Central London Plan, Strategic Corridors The Cut / Blackfriars Road, Option 4

Stage 1 Road Safety Audit

Ref: 3589.08.01.02/008/B300/BOR/2020

Problem Locations

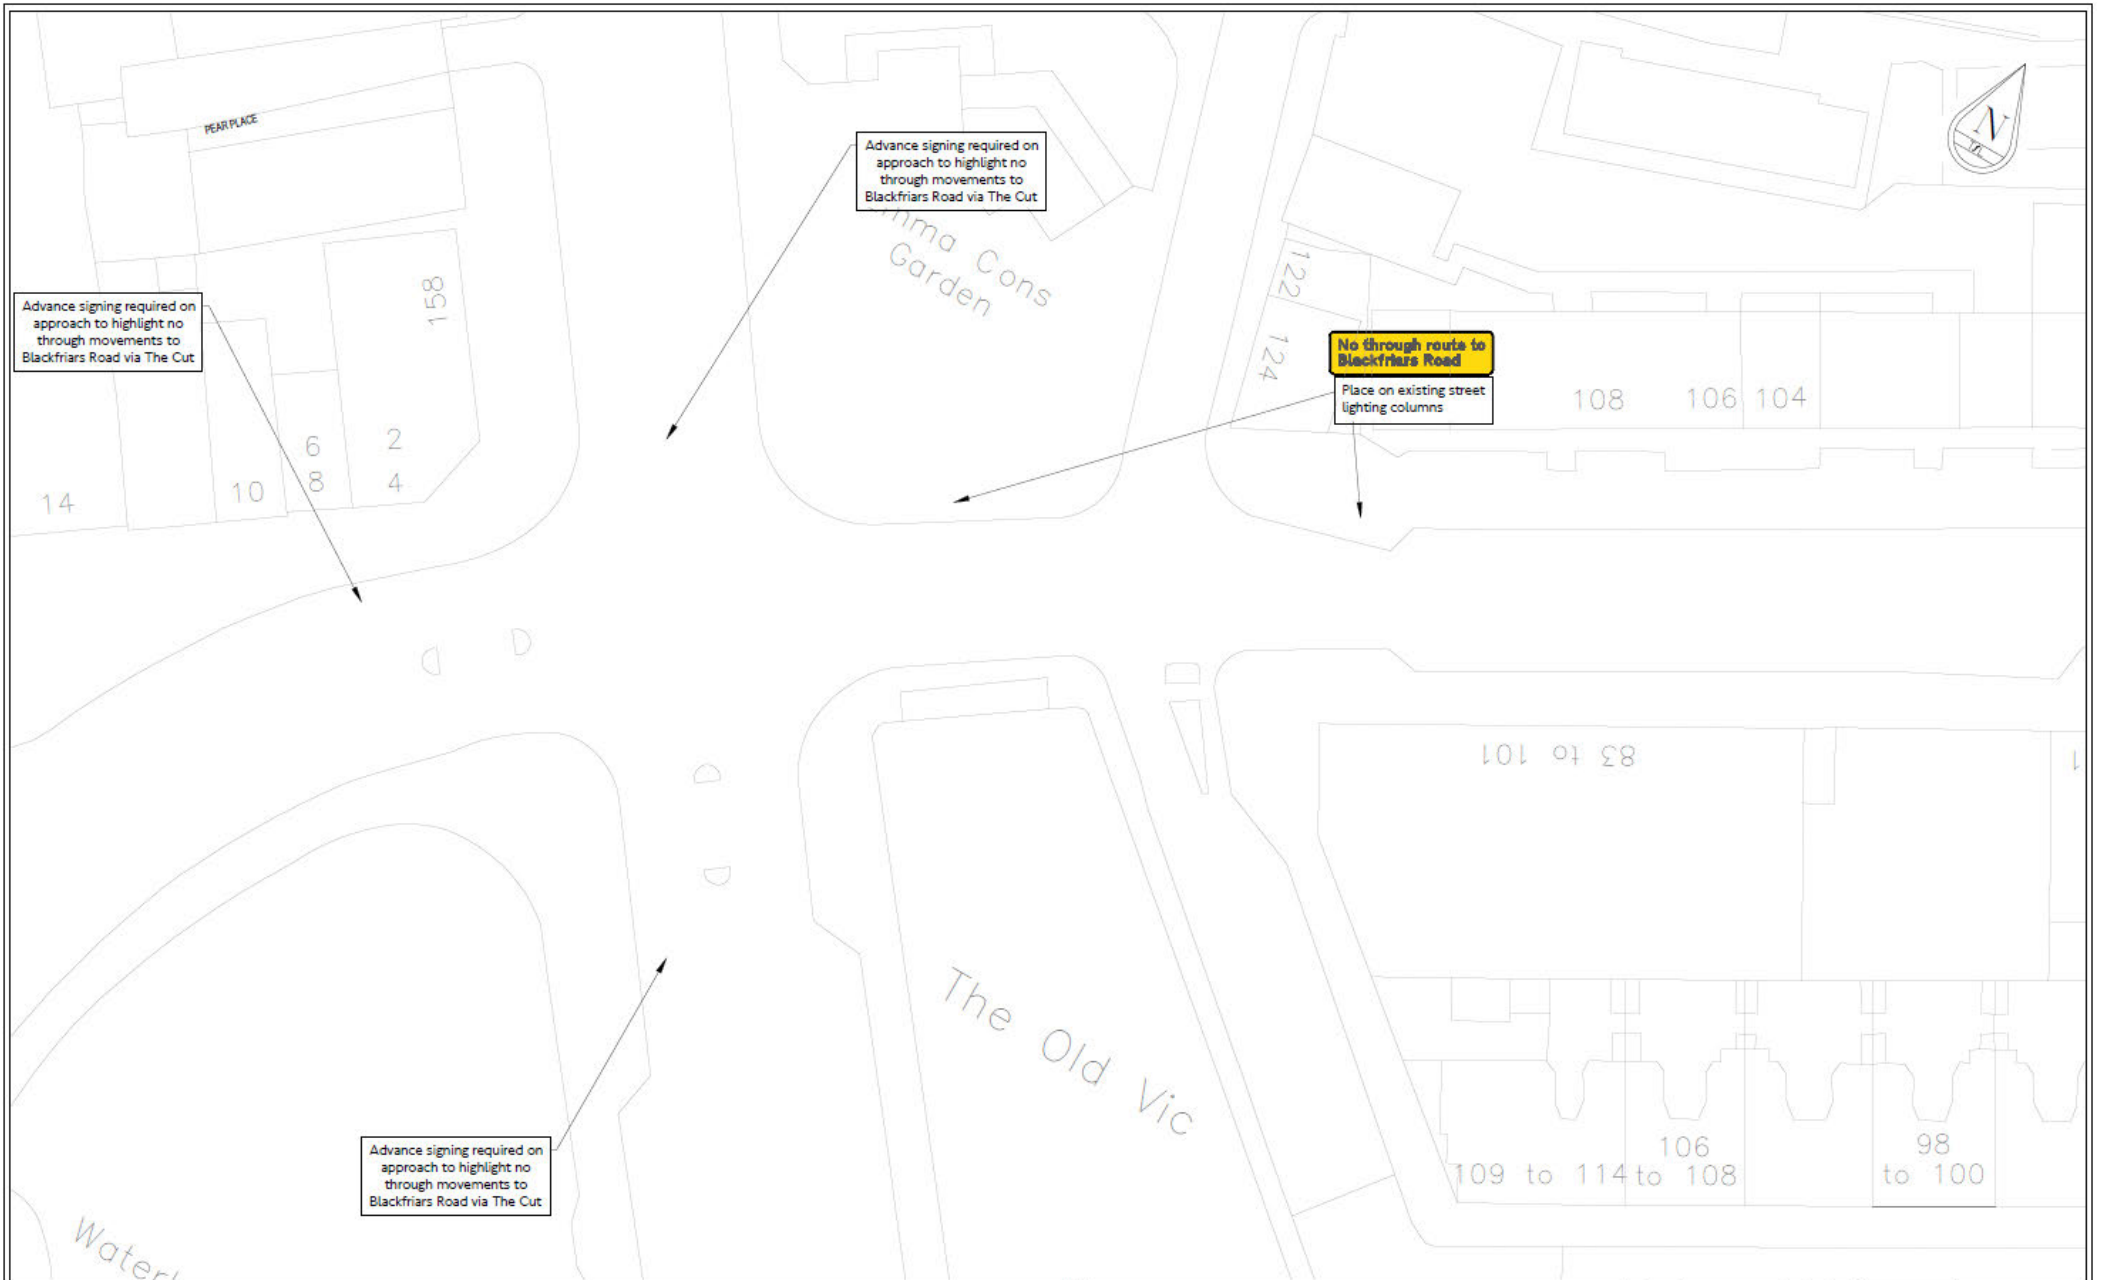
Location: A - The Cut junction with Hatfields.

Summary: Obscured signs may increase the risk of road user collisions.

The design proposes new signage at the eastern end of the restricted section, to inform westbound road users of the restrictions and the need to turn right from The Cut. Whilst it is recognised that the locations are indicative at this stage of the design, the nearside Diag.609 'turn right except cycles' is shown to be installed on a lamp column which is not present on site. The nearside Diag.619 sign is shown in an area which contains a lot of existing street furniture including a lighting column, benches and planters with trees in. The offside sign is proposed close to a bollard and 'controlled zone' sign. Poor sign positioning may result in obscuration and limit road user awareness of the restrictions and permitted movements, potentially increasing the risk of collisions in the area.

The positioning of road signs should be revisited during the detailed design stage with care taken to ensure all signs are clearly visible and do not restrict pedestrian movements. The use of the 'controlled zone' sign post should be investigated, since the existing sign may be redundant, given the proposed access restriction.

Location: B - The Cut junctions with Hatfields and Short Street.

Summary: Removal of markings may result in ambiguous priorities and poor vehicle positioning, increasing the risk of conflict.

The existing give way markings and centrelines are proposed to be removed in both side roads as part of the scheme. This may result in the operation of the junctions becoming less apparent to road users. For example, drivers may be more likely to cut the corner when turning off The Cut, risking head-on collisions with opposing traffic. The absence of give way signs may also reduce cyclist / delivery driver awareness of the priorities and may lead to failure to give way collisions.

Additional markings and signage should be provided to reinforce the priorities and encourage good vehicle positioning. For example, centreline markings could be continued from the side roads and into the cut to make it clearer that vehicles are expected in both directions, with the proposed give way markings on The Cut angled to give some deflection to ahead traffic.

The concept design has been developed on an OS base supplemented by adjustments from historical Google Street View images. Covid-19 working restrictions have prevented the design team from visiting the site. It is therefore recognised that some existing street furniture may either be incorrectly positioned or missing. The detailed designers are to be made aware of this and required to review the design whilst on site to ensure accuracy.

There is scope to temporarily remove the existing controlled zone parking signs to improve visibility and avoid any confusion. Other superfluous signing should also be identified and either removed or covered over. Discussions between the detailed designer, contractors and boroughs should be undertaken to confirm.

This will be considered further as part of the detailed design and checked upon scheme completion.

Design Organisation Response	Accepted/ Part Accepted / Rejected
On request of the LB Lambeth, the priorities of the junction have been changed at either end of the point closure to further emphasise the point closure. The Cut is proposed to have clear priority junction markings and supporting road signs to highlight the closure and change of layout. There are currently limited carriageway markings on The Cut, introducing an element of uncertainty which is reflected in lower speeds and greater driver caution. On going monitoring is recommended and any adjustments made as required.	
Client Organisation Comments	
Will ensure on going monitoring and action adjustments as necessary.

Project Reference: **CSDCUT-TFL-FA-ZZ-DR-TE-04-0001**

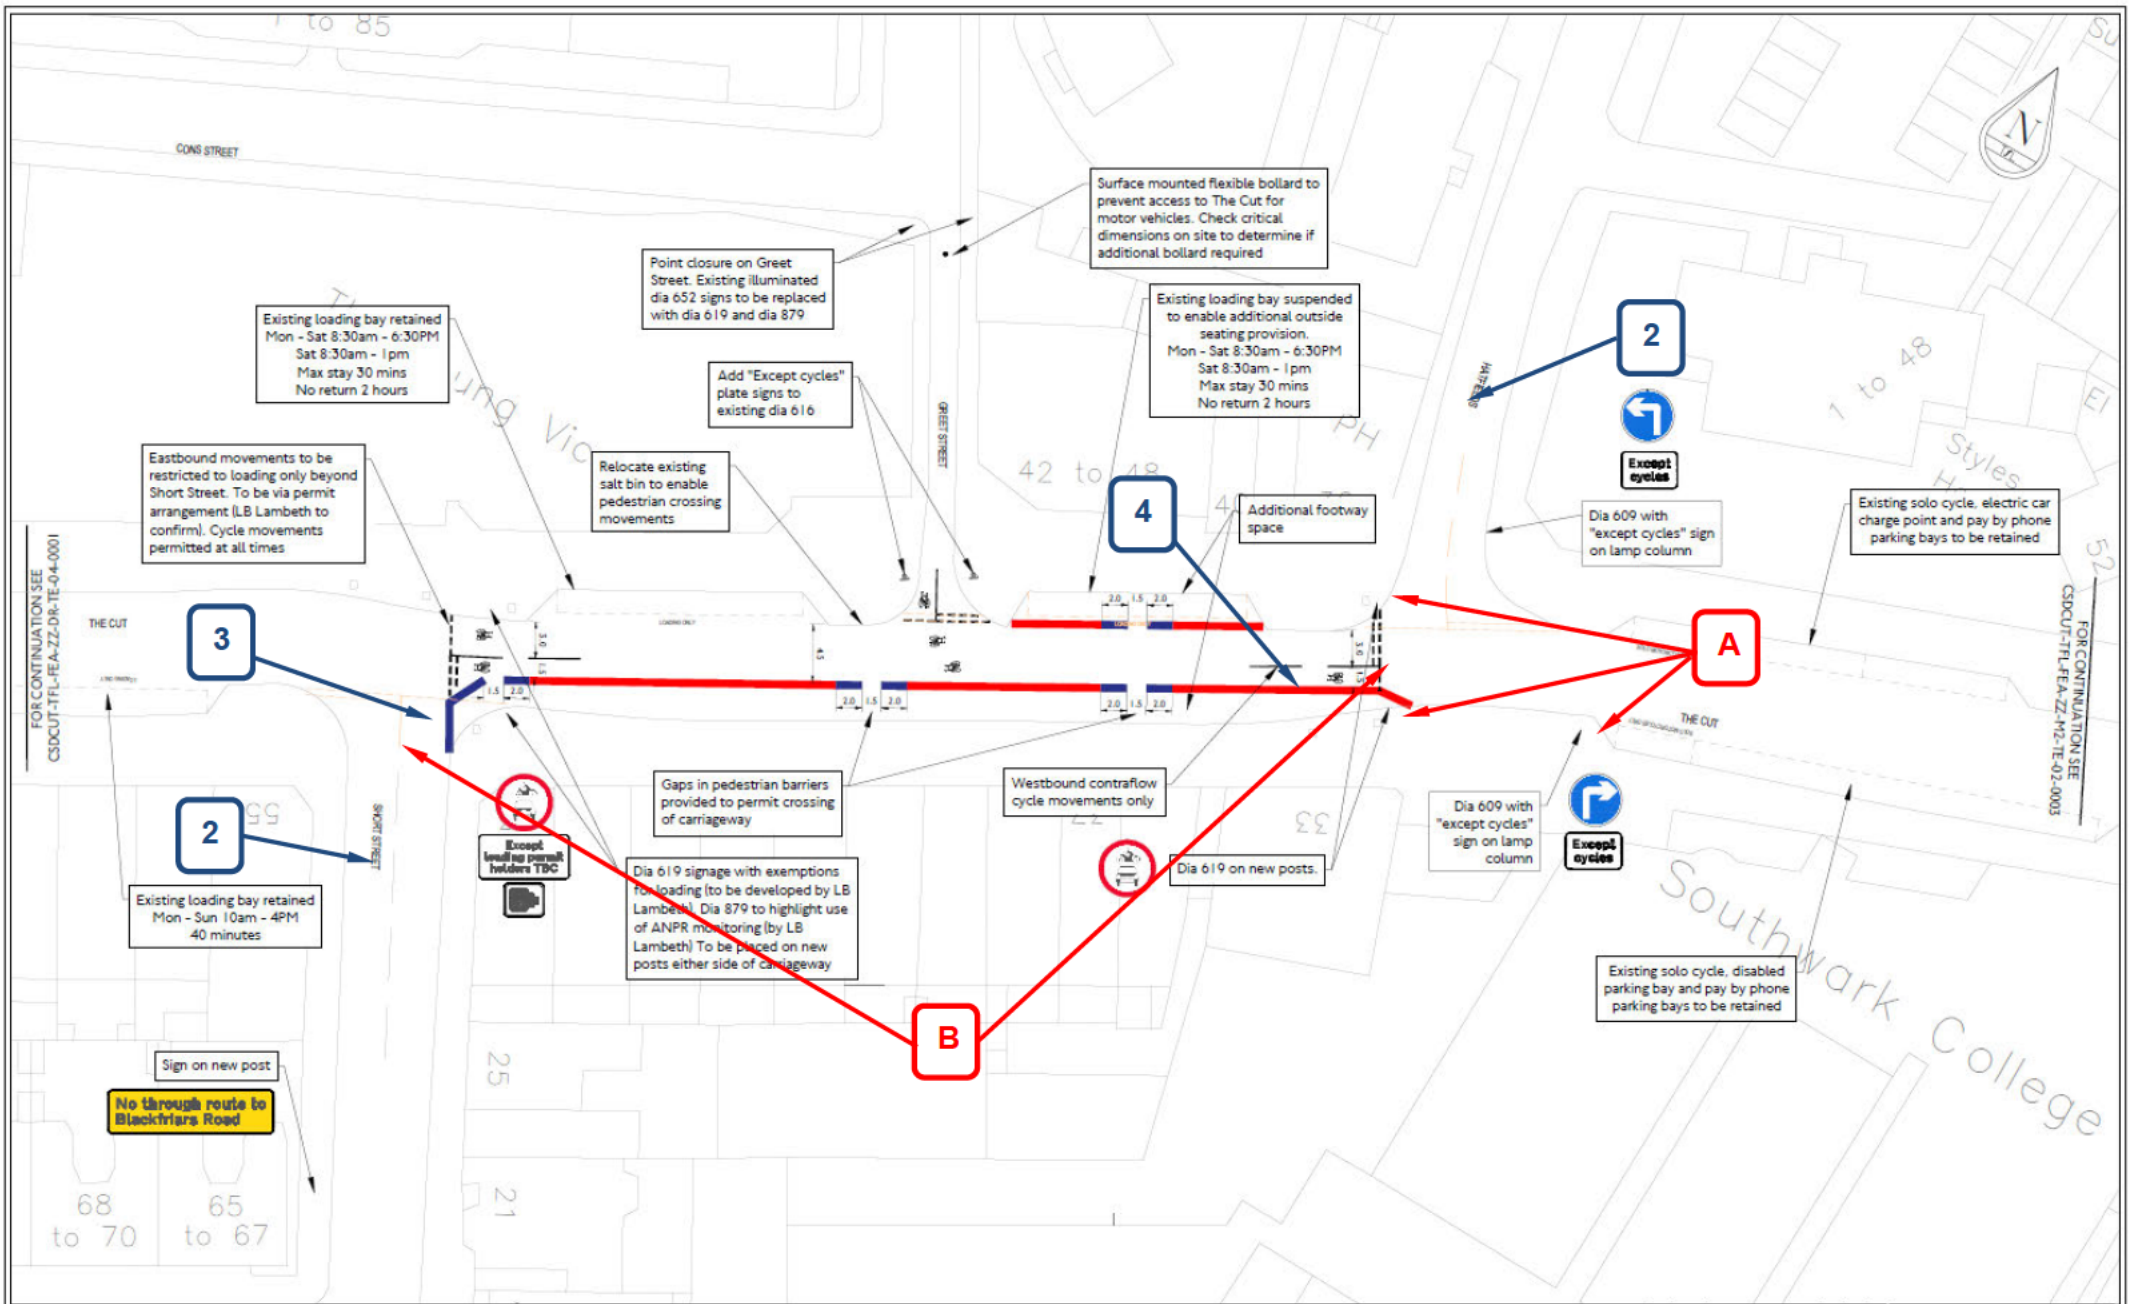
Location: 1 – The Cut junction with Blackfriars Road

The proposed nearside footway buildout outside Southwark Underground Station reduces the available space for the two-stage cycle right turn into Union Street. Whilst the Audit Team understands that this movement is relatively light, it is recommended that the Designer investigates whether there is sufficient capacity to cope with anticipated demand. It may be necessary to reduce the eastern traffic signal island to increase space for waiting right turners.

Location: 3 – The Cut junction with Short Street.

The drawing indicates that the water filled barrier may block the pedestrian desire line across the Short Street junction uncontrolled crossing. It is recommended that the positioning of the barriers is amended to ensure the crossing is not impacted.

Location: 4 – Outside the Hope and Anchor.

The proposed barriers will block the existing uncontrolled crossing (across The Cut) to the west of the Hatfields junction. Whilst it is recognised that there are gaps proposed in the barrier to the west, pedestrians will have to step down to carriageway level which is considered a reduction in provision for mobility impaired pedestrians as well as being away from the desire line to/from the Hatfields footway. It is recommended that the existing pedestrian facilities are retained with consideration given to providing more pedestrian permeable barriers given the low levels of vehicular traffic expected.

Design Organisation Response	Accepted / Part Accepted / Rejected
It is understood that the two-stage right turn is relatively lightly used and the proposed arrangement is sufficient for current demand. The recommended 2.65m turning radius for a conventional bicycle stated in LTN2/08 has been applied when assessing turning movements and there is sufficient space to make the turn.	
Client Organisation Comments	
All opinions noted.

Design Organisation Response	Accepted / Part Accepted / Rejected
Care has been taken to ensure the barriers do not obscure the existing tactile paving on Short Street. As stated earlier in this document, the design is based on an OS base so accuracy cannot be guaranteed. On site measurements / adjustments are recommended by the detailed designers to ensure the crossing is not impacted.	
Client Organisation Comments	
Care will be taken in detailed design, but will be assessed on site to ensure sensible placement of the water filled barriers.

Design Organisation Response	Accepted / Part Accepted / Rejected
The highlighted blocked uncontrolled crossing has been raised by the borough and the detailed designers made aware. A gap is to be provided in the location of the existing tactile paving.	
Client Organisation Comments	
Care will be taken in detailed design, but will be assessed on site to ensure sensible placement of the water filled barriers.
